DA ASSESSMENT REPORT

DA No. P969

Address: Lot 257 (151) Avon Terrace, York

Proposal: Change of use to a retail book store.

DIAGRAM 1

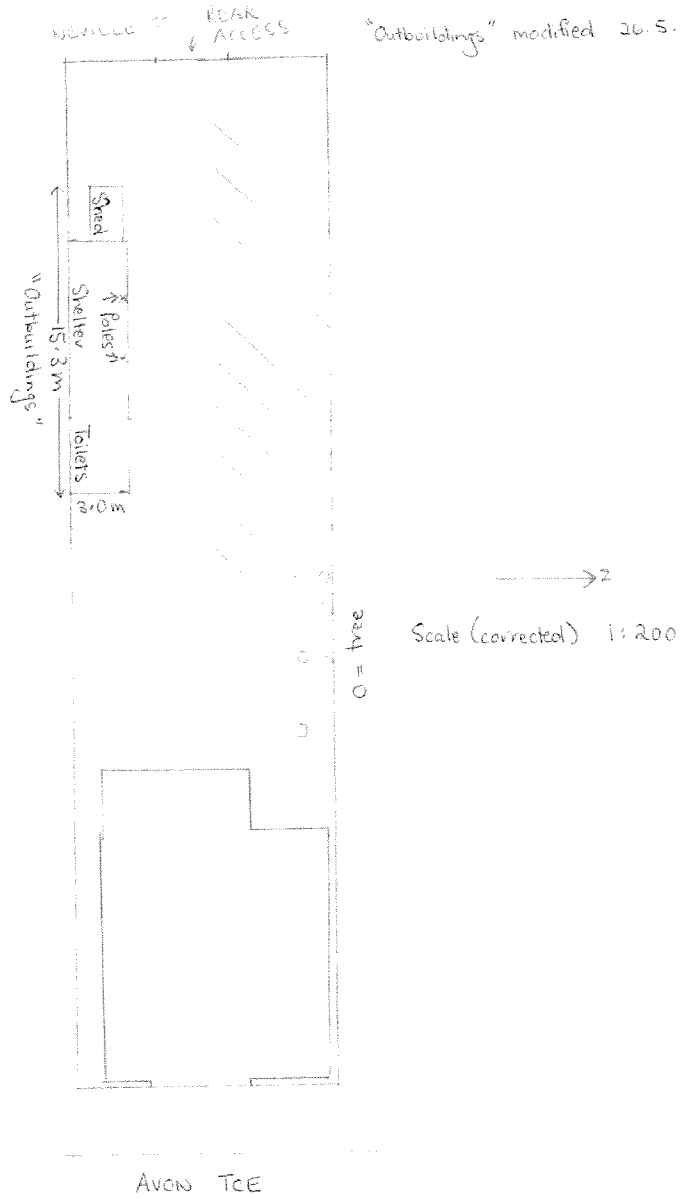
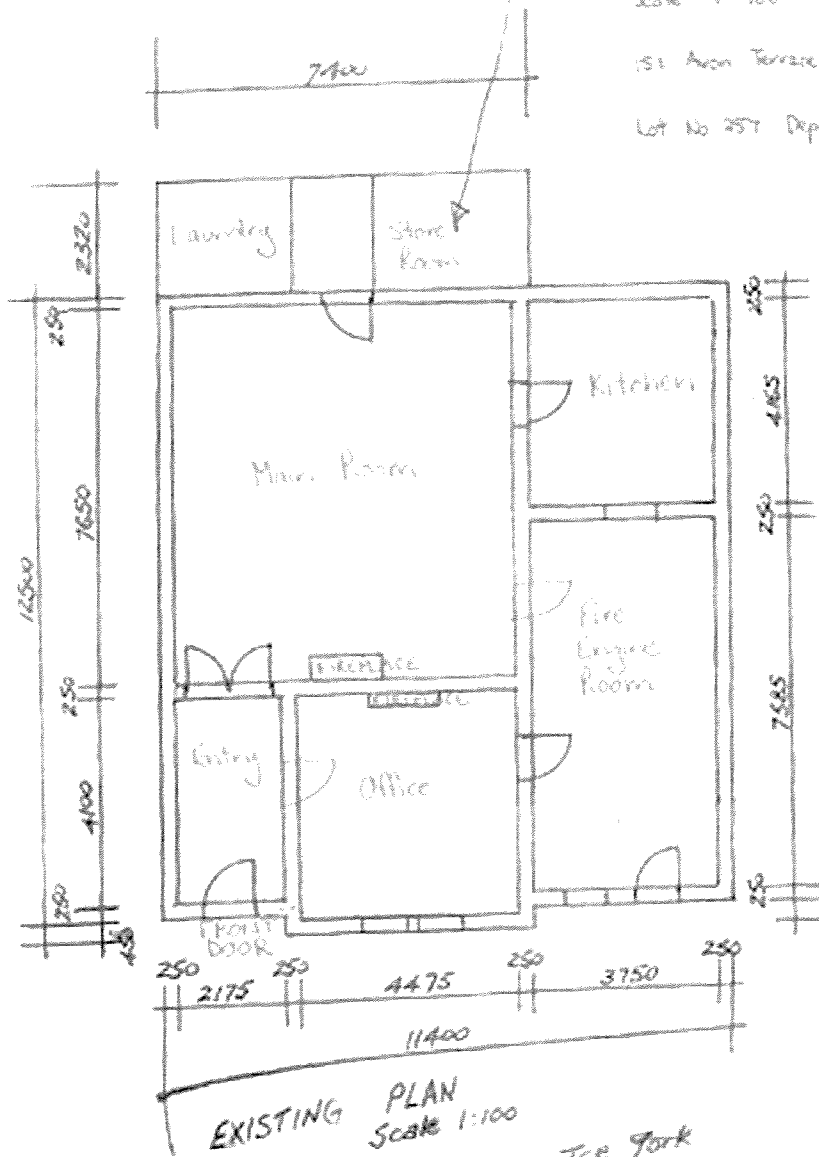
9 spaces have been provided on the rear of the property. It has been suggested that this will be used predominantly by staff as the main entrance is at the front i.e. Avon Terrace.

Whilst the amount of parking provided on the property is in accordance with the scheme, the layout does not comply with the requirements of Schedule 4. In particular, there is only a single access point, therefore the single accessway will be two way (as reverse egress from retail parking areas is not provided for in the scheme, nor is it considered to meet safe access requirements). The distance provided between the angle parking bays and the nearest structure is insufficient to enable two way access. Safe, two way access will require a modified parking layout, which may not enable the provision of 9 bays as currently shown on the car parking plans.

As the rear parking area will generally only function as staff parking and sufficient customer parking is available in nearby public parking areas, a reduction in parking, to meet the minimum manoeuvring requirements of the scheme, can be supported. A condition of approval is recommended to provide staff parking on site (a minimum of 4 bays) in accordance with the manoeuvring requirements of Schedule 4 of the scheme, with the need for onsite public parking waived at the discretion of Council.

However, there is still a necessity to provide car parking spaces for staff, hence the requirement for 4 spaces – a 50% reduction in the requirement.

Note 5: The four (4) staff parking bays are to be provided and suitably constructed to the satisfaction of the local government, meeting the minimum manoeuvring requirements of Schedule 4 of the scheme for two way access. At least one (1) of the spaces is to comply with Disabled Access provisions of AS/NZS2890.6-2009.
